EDWIN I. HATCH NUCLEAR PLANT UNIT 1

AMENDMENT TO FACILITY OPERATING LICENSE

Amendment No. 23
License No. DPR-57

SAFETY EVALUATION BY THE OFFICE OF NUCLEAR REACTOR

Figure 1 Plug Installed in Core Plate

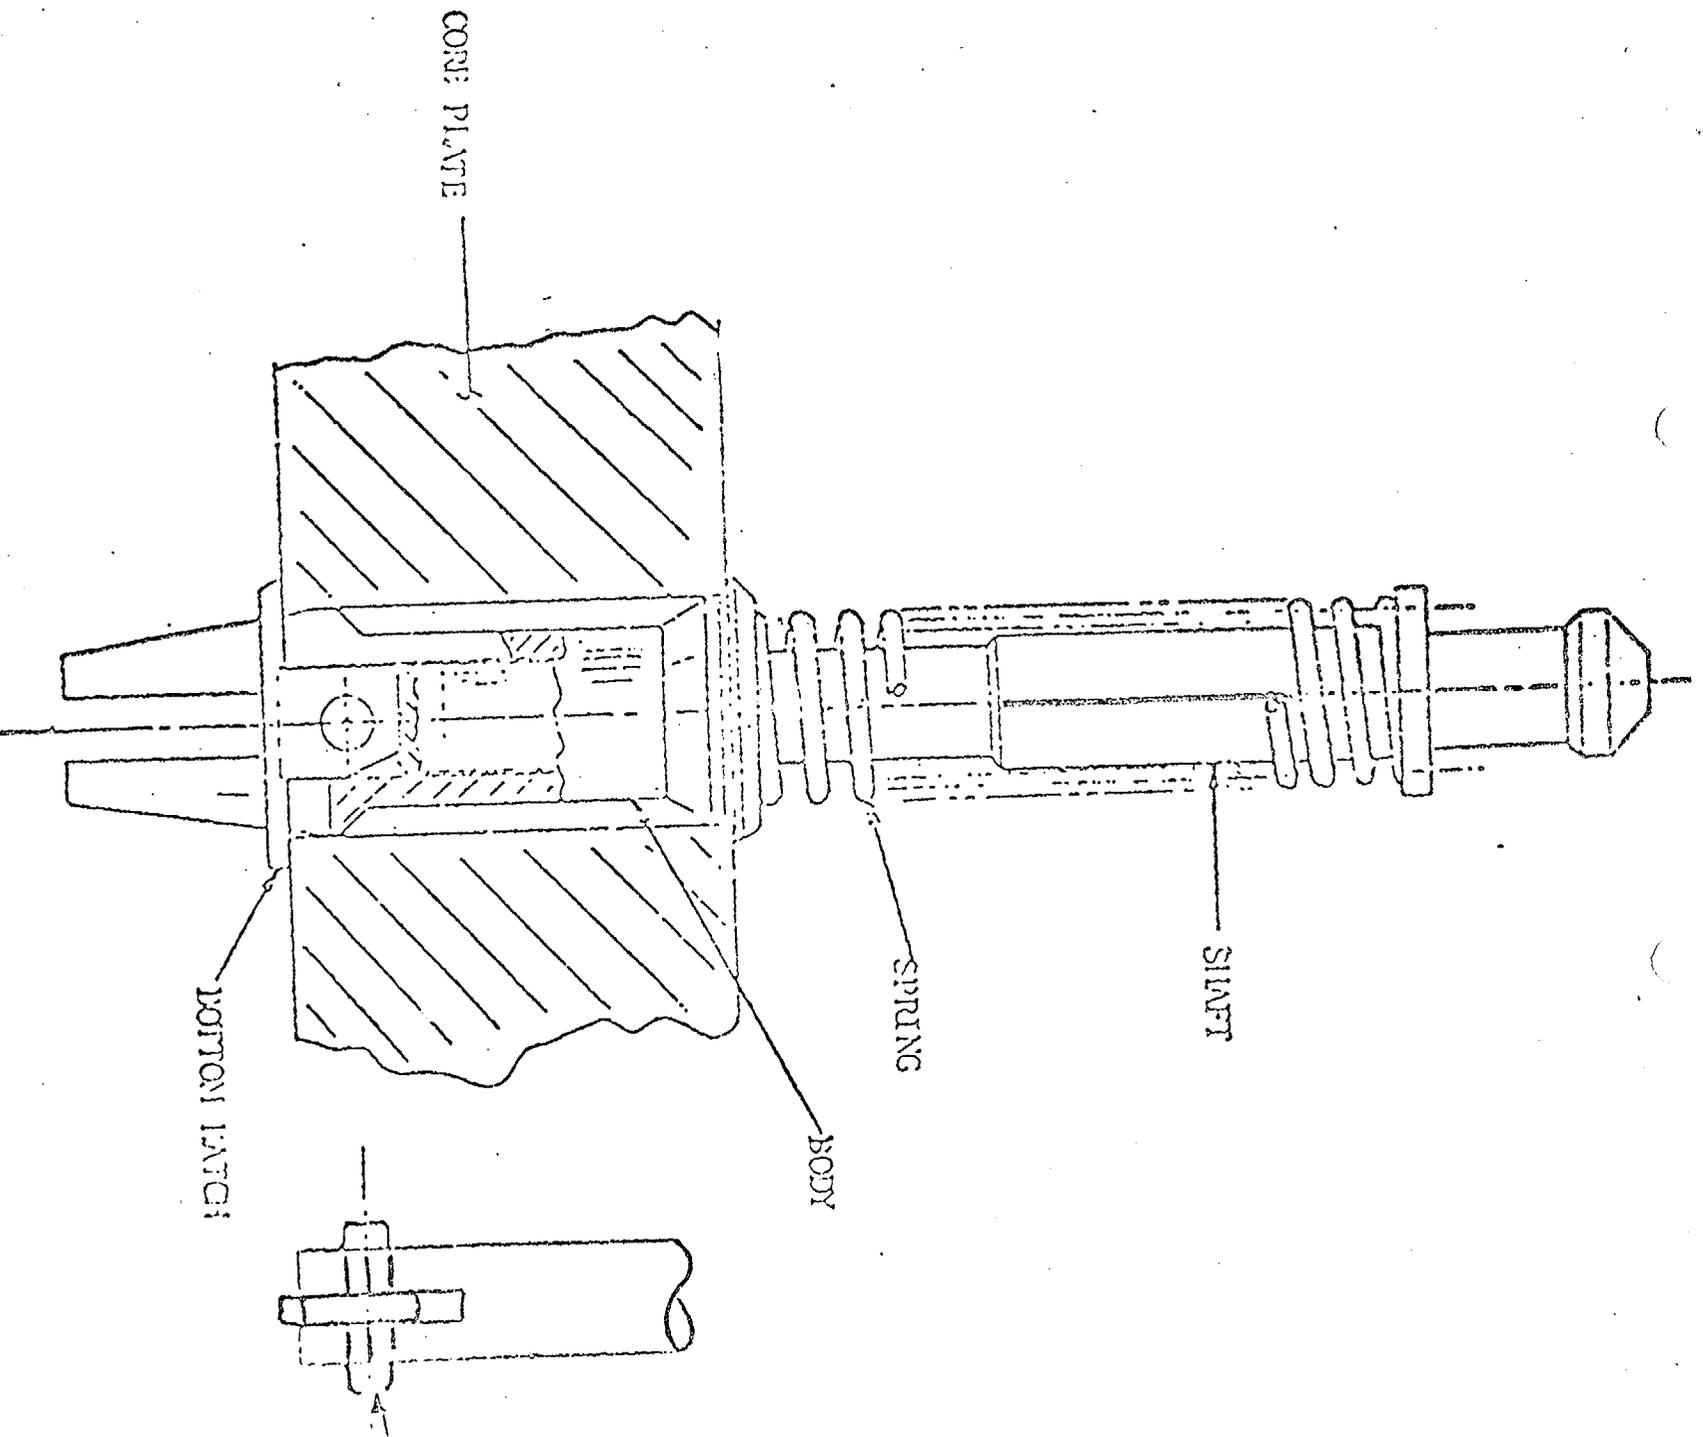
The plug consists of five basic parts, as shown in Figure 1. Identical plugs have previously been installed at Vermont Yankee, Pilgrim, Cooper and Duane Arnold. The body provides a means of guiding the device into the bypass flow holes as well as a shoulder to support the plug and form a seal against water flow. The shaft extends through the body. A knob is provided at the top of the shaft to provide a means of grabbing the plug during installation and extraction. At the bottom, the latch is attached to the shaft by a pin. The latch is free to rotate during installation. The spring acts against the body and shaft during normal operation to provide the force necessary to offset the pressure differential acting on the body.

During installation, the plug has its latch rotated 90 degrees from its installed position and withdrawn and locked in the body. The shaft is gripped by the installation tool, and the plug is inserted into the bypass flow holes. The body engages the rim of the hole. The shaft is pushed to its full extension, thus lowering and unlocking the latch below the underside of the core plate. The latch then rotates 90 degrees and bears on the bottom of the core plate. After insertion, the plug is pulled with about 30-pound force to test the placement.

The plug can be removed by gripping the top of the shaft with an extracting tool and applying a force of about 500 pounds. The latch's legs will be plastically deformed and the entire plug withdrawn. The plugs previously installed at Vermont Yankee were removed with no abnormalities or loose pieces reported. The force required for removal varied from 500 to 1300 pounds.

Based on a review of the design, the installation methods, and the previously successful operating experience at Vermont Yankee, Pilgrim, and Duane Arnold, we conclude that the plugs can be installed without damage to core components, that they will not fail so as to result in loose parts in the core or result in unplugging of the bypass flow holes, and that they can be removed, if necessary, without damage to core components. Thus, the modification is reversible.

Accordingly, we conclude that the installation of the plugs is acceptable. Operation with plugged bypass holes is still under review and will be the subject of a separate licensing action.
